ELKO NEW MARKET - PLANNING COMMISSION MEETING

TO: WARREN BARSNESS, DALE RUNKLE, JOEL COOPER & JIM CONNELLY
FROM: RENEE CHRISTIANSON, COMMUNITY DEVELOPMENT SPECIALIST
SUBJECT: REQUEST FOR REZONING FROM B1 (NEIGHBORHOOD BUSINESS DISTRICT) TO PUD (PLANNED UNIT DEVELOPMENT), AND PRELIMINARY PLAT APPROVAL OF BARSNESS 1ST ADDITION, CONSISTING OF 3 LOTS AND 1 OUTLOT ON 10 GROSS ACRES.
DATE: APRIL 24, 2018

Proposed PUD Zoning & Preliminary Plat, Barsness 1st Addition

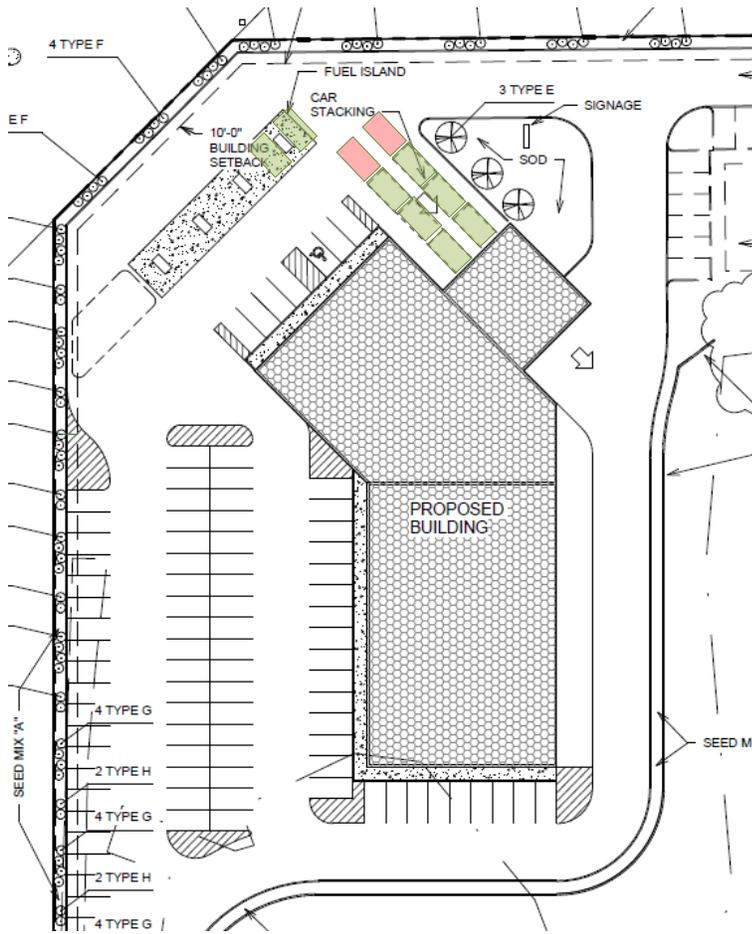
The City Code states that “the setback between the pump islands’ curb face shall be at least 24”. The plan submitted shows 23’ between pump island curb faces. The proposed 23’ is an improvement over the concept plan which showed 20’ spacing and is acceptable to City staff.

Staff notes that the building renderings shown on the “Concept Elevations” drawing dated 11-29-17 seem to depict space for two vehicles at each fuel pump. The developer has verbally indicated that there would be room for only one pump and vehicle (not double stacked). The site, as currently designed, does NOT accommodate space for two vehicles. The rendering should be revised to accurately depict the single fueling stations.

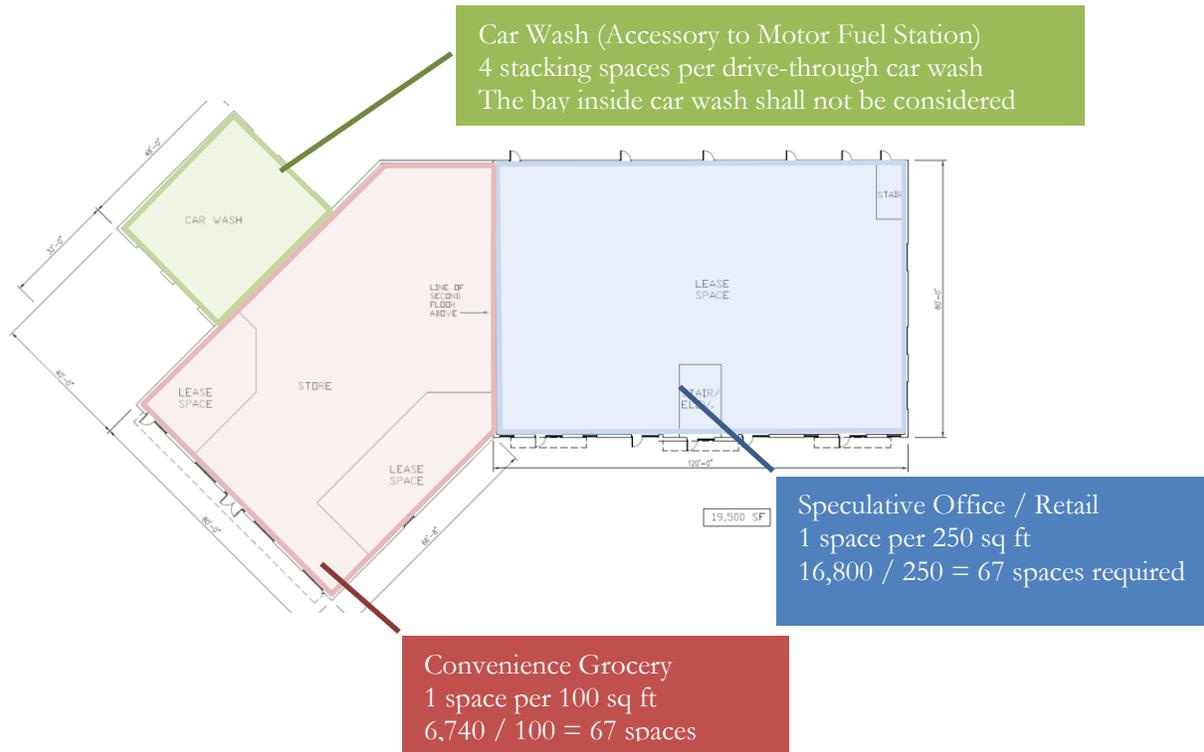
The landscaping plans depict that vehicles would enter the car wash on the northwest side of the building. The adjacent diagram depicts how vehicles would stack as waiting to enter the car wash. The Planning

Since the concept plan was presented, the developer has moved the car wash portion of the building approximately 10' to the southeast to create an 10 additional feet of stacking space. Although the changes made since the concept plan review do improve the vehicle stacking situation, staff believes that the vehicle stacking areas shown in red would still cause conflicts with traffic flow through the site, in the area of the gas station. Staff is seeking input from the Planning Commission regarding this matter. Car wash stacking spaces are often designed to stack behind / in back of the buildings.

➤ The plans shall be revised so that the required car wash stacking spaces are provided and clearly identified, and do not create any conflicts with traffic circulation on the site.

Revised Landscape Plan

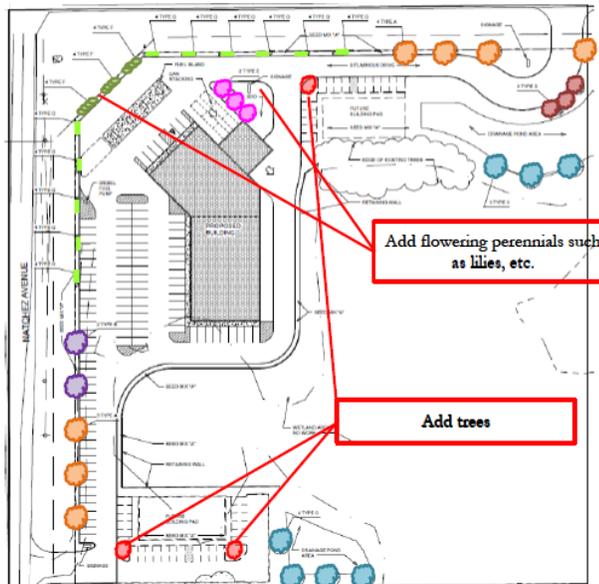
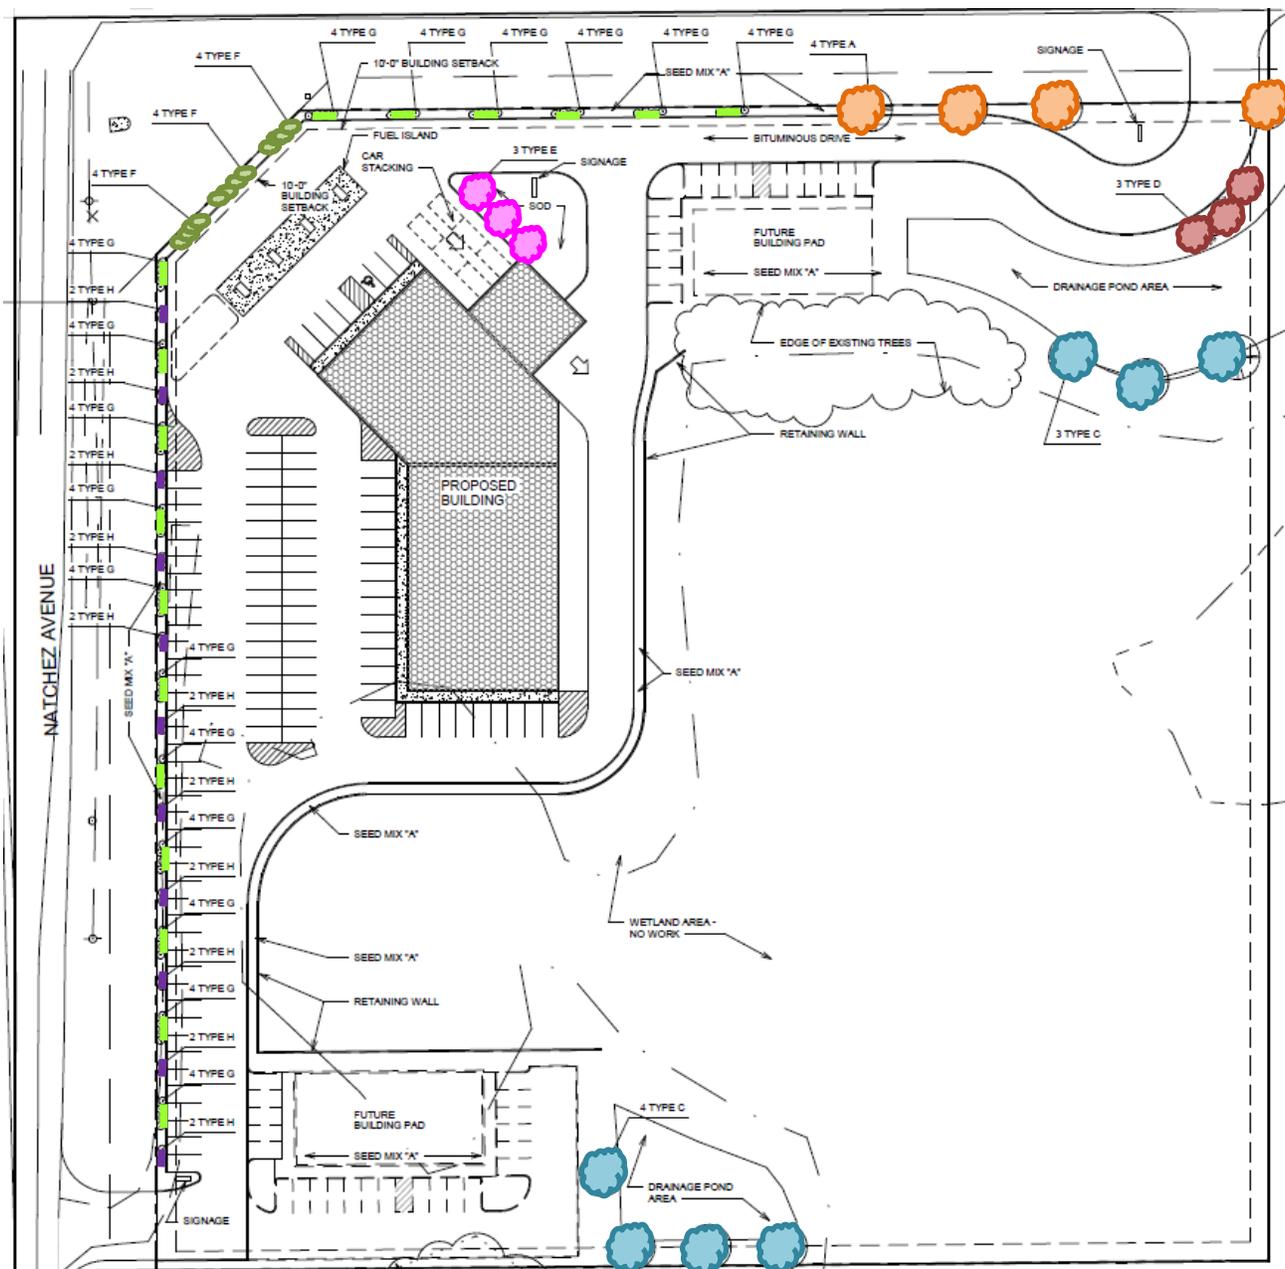
The landscape plan does not meet the requirement of Title 11-26A-4 which requires not less than a 15' wide landscaped area adjacent to the road right-of-way. The applicant is proposing only 5' between the proposed exterior curbing and the property line abutting the right-of-way; motor fuel stations specifically require an area of not less than 15' wide. Both the Planning Commission and City Council discussed this matter during the concept plan review, provided the following feedback to the applicant:

Staff's opinion is that the landscaping plan has been changed, but not significantly enhanced as suggested by both the Commission and Council. Some deciduous trees previously proposed along Co Rd 91 have been changed to shrubs, the previously proposed willow trees have been changed to river birch, and Miss Kim lilacs have been added along Co Rd 91. Other than these items, the plans are very similar.

Staff requests Planning Commission feedback regarding whether the revised site design and landscaping plan have sufficiently satisfied their expectations in terms of allowing the trade-off for reduced easement widths around the perimeter of the plat and reduced green space requirements (5' vs 15') in front of the motor fuel station.

"The landscape plan shall be amended to remove the proposed willow trees located near the stormwater ponds, add trees in possible parking lot bump-out areas, and add flowering perennials throughout the site."

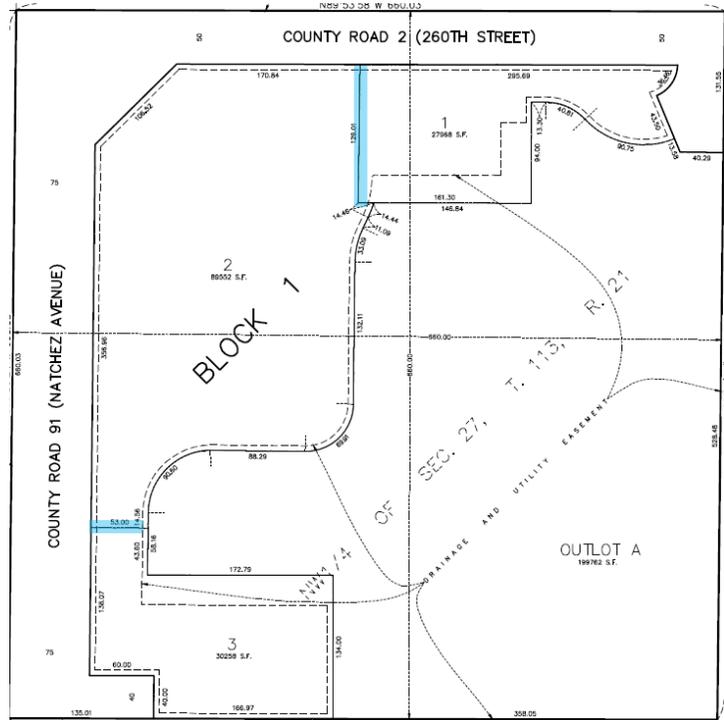
The preliminary plat drawing submitted continues to depict 5' easements along lot lines that abut the street and adjacent properties, and no easements along interior lot lines.

Staff requests Planning Commission feedback regarding whether the revised site design and landscaping plan have sufficiently satisfied their expectations in terms of allowing the trade-off for reduced easement widths around the perimeter of the plat.

"The Planning Commission is open to a reduced drainage and utility easement along the perimeter of the site if the site can be significantly enhanced in terms of design and landscaping, and it is demonstrated that the site and surround area can function with the reduced easement area."

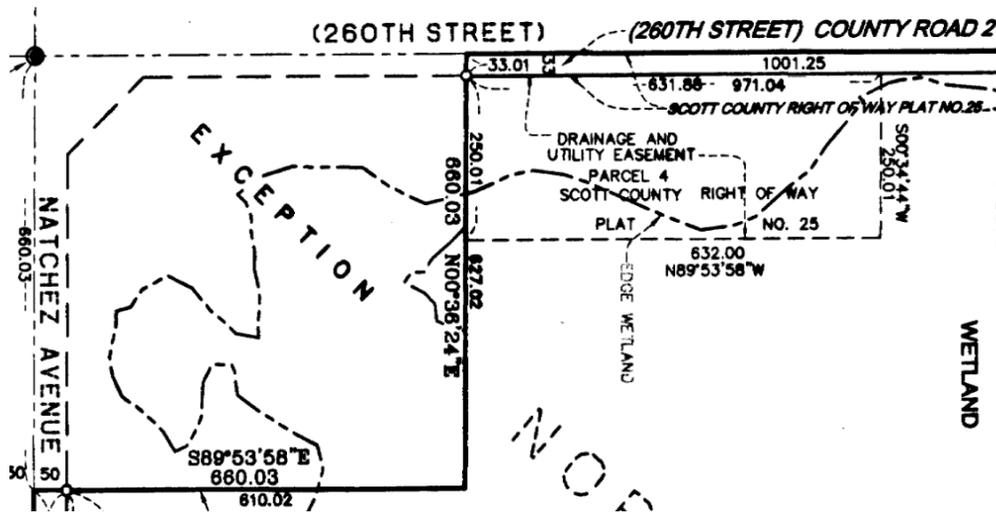
The current plan does show grading within the buffer area. Approval of the plan as submitted would be approving a reduced wetland buffer from the required 30' (average) and 25' minimum to 0'. (average buffer unknown.) There was Planning Commission and City Council support of this deviation during the concept plan review.

“The first 25’ of buffer, as measured from the wetland, cannot be disturbed during project construction (i.e. cleared or graded, except for temporary disturbances for public roads and utility construction) and shall be protected from disturbance with temporary fencing prior to construction. Vegetation can be replaced and

site soils preparation work completed within the first 25' if necessary to establish acceptable buffer vegetation in accordance with these wetland regulations.”
